STATE OF IDAHO
DEPARTMENT OF WATER RESOURCES
ADJUDICATION CLAIM VERIFICATION REPORT

CLAIM NUMBER: A51-00125

RE: Snake River Basin Adjudication (SRBA) Notices of Claims for Three Creek Ranch

Claim(s) : 51-00125

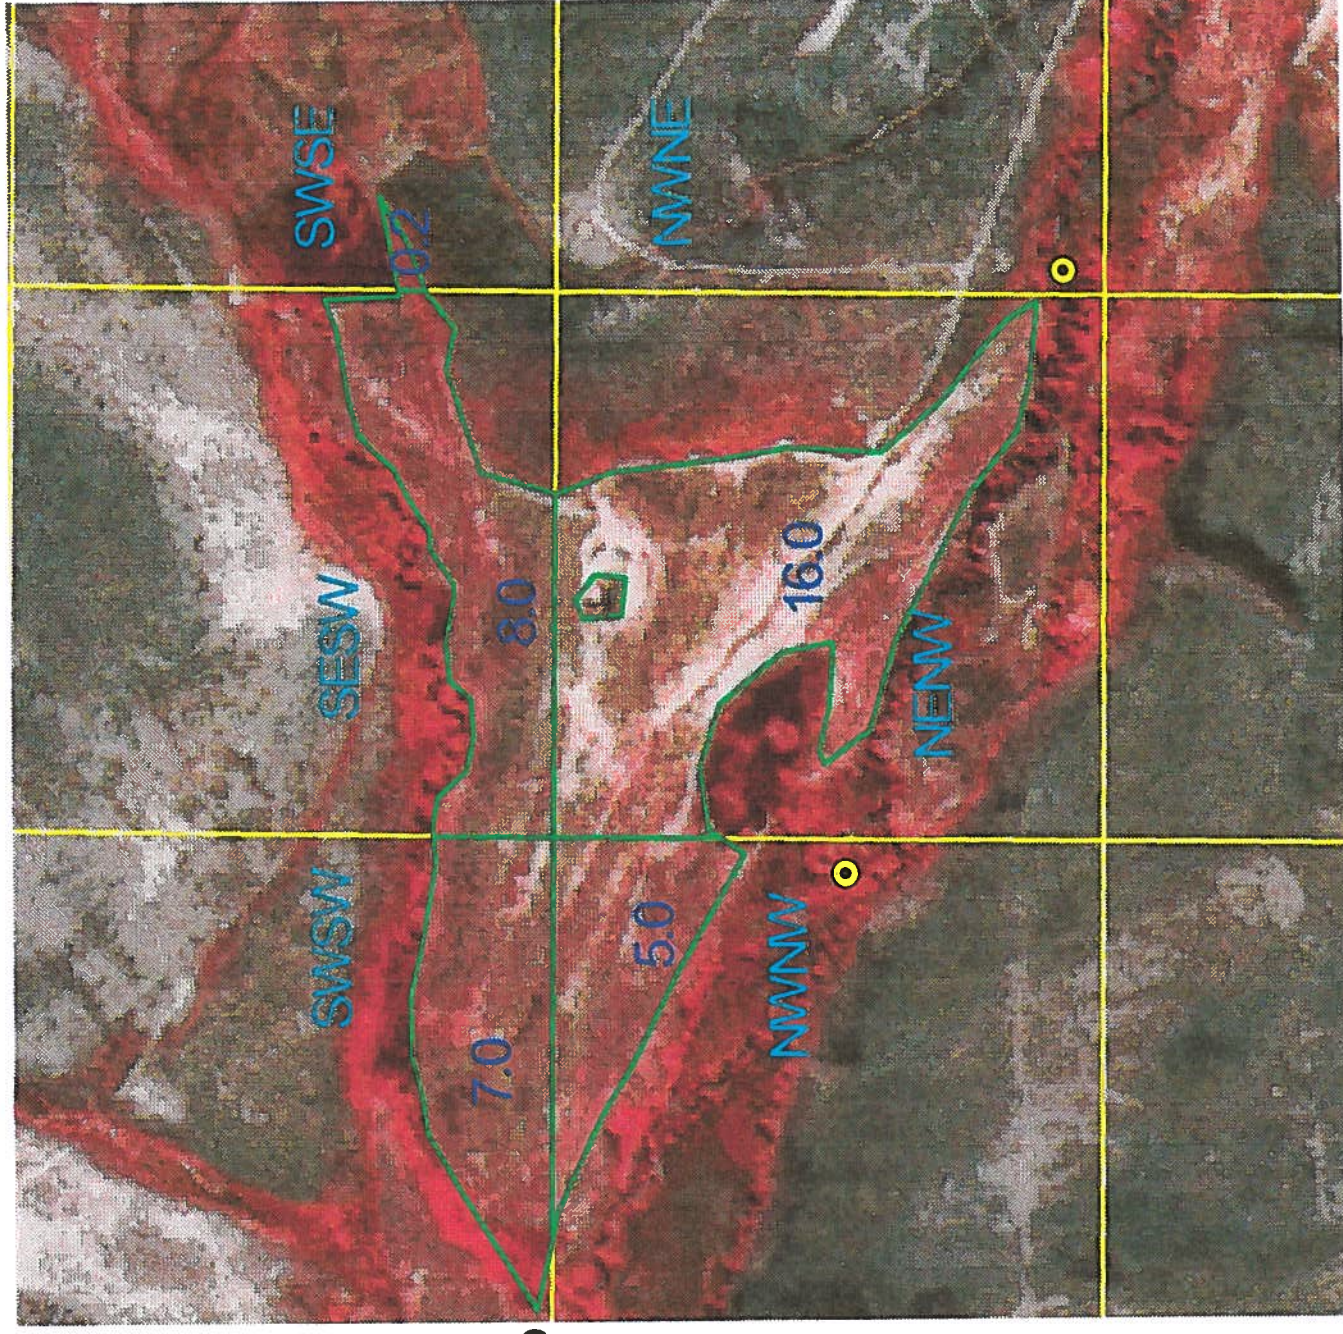
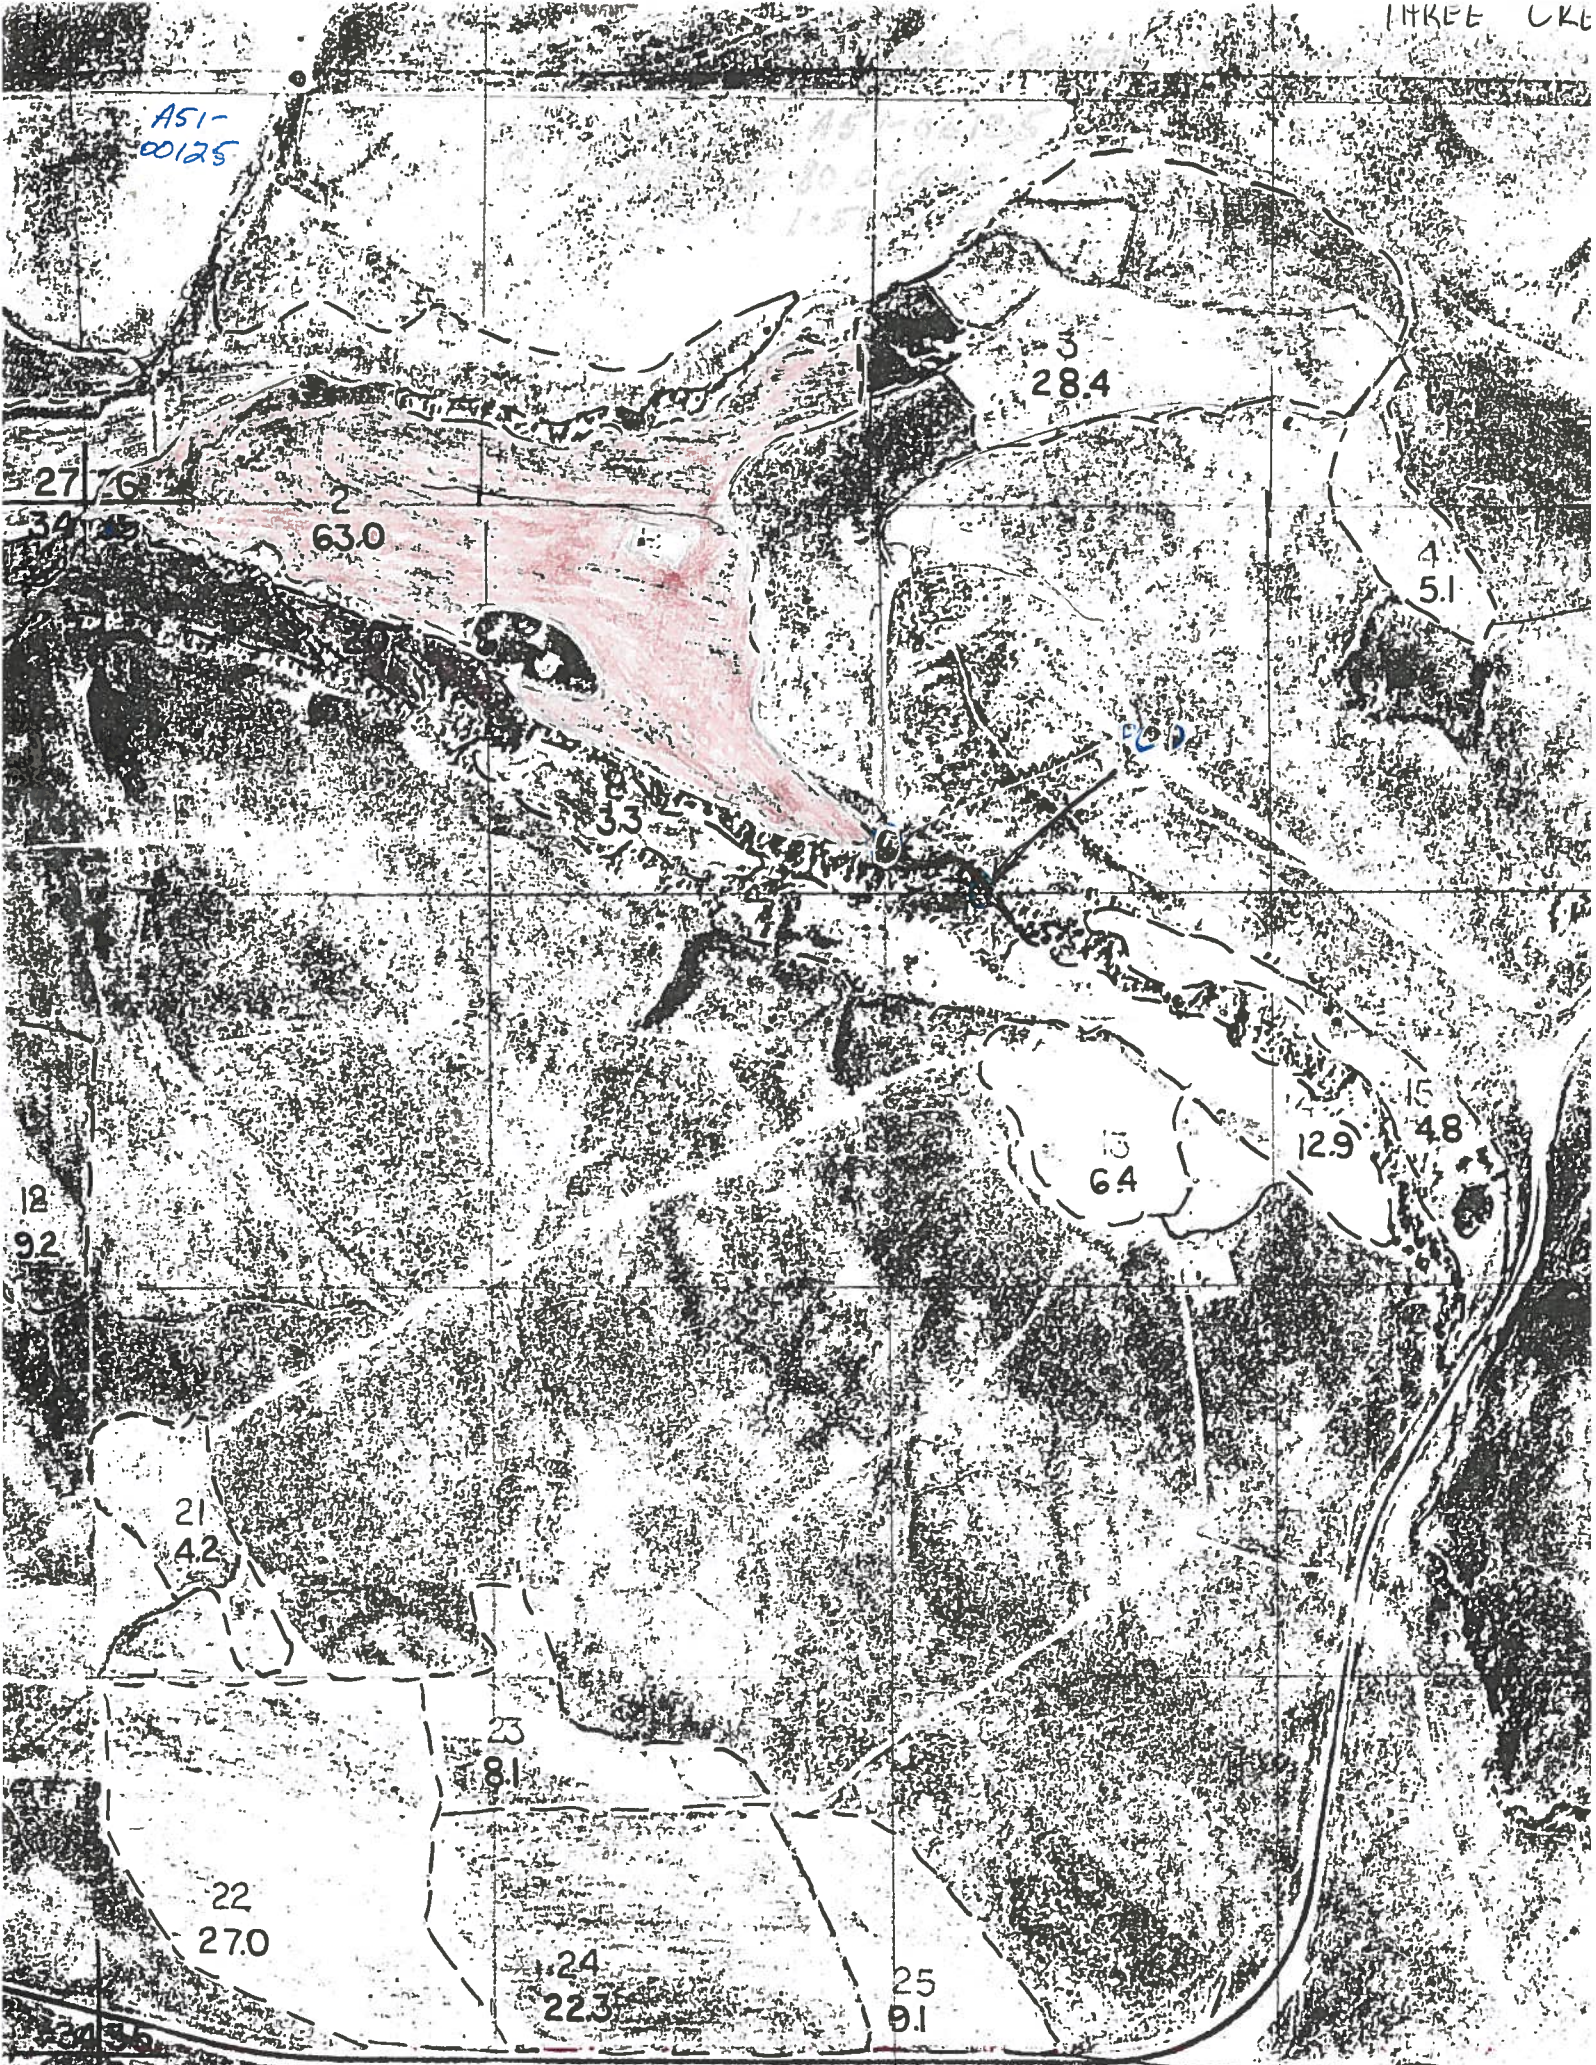
NOTES: 12/16/1996: Point of diversion is located just to the east of where Tra Lien has indicated its location on his NAPP-based map, close to the QA line. The POD could not be in the location claimed, as the creek does not flow through that 10 acre tract. 177

NOTES: 12/13/1996. Record acres are based on the 1987 ASCS map. Using the
for grid method. These recommendations may change if technology allows
for more accurate assessments of the irrigated acres. The place uses
the irrigated acres between Deep Creek & Mud Flat Draw. Although the
decreased place 7 use is the N 1/2 NW 1/4, this point of diversion also
extends in the S 1/2 SW 1/4 - that portion that is south of the Mud Flat Draw
drainage. ASCS identifies the POB as field No. 2. 0777

Total Acres = 36
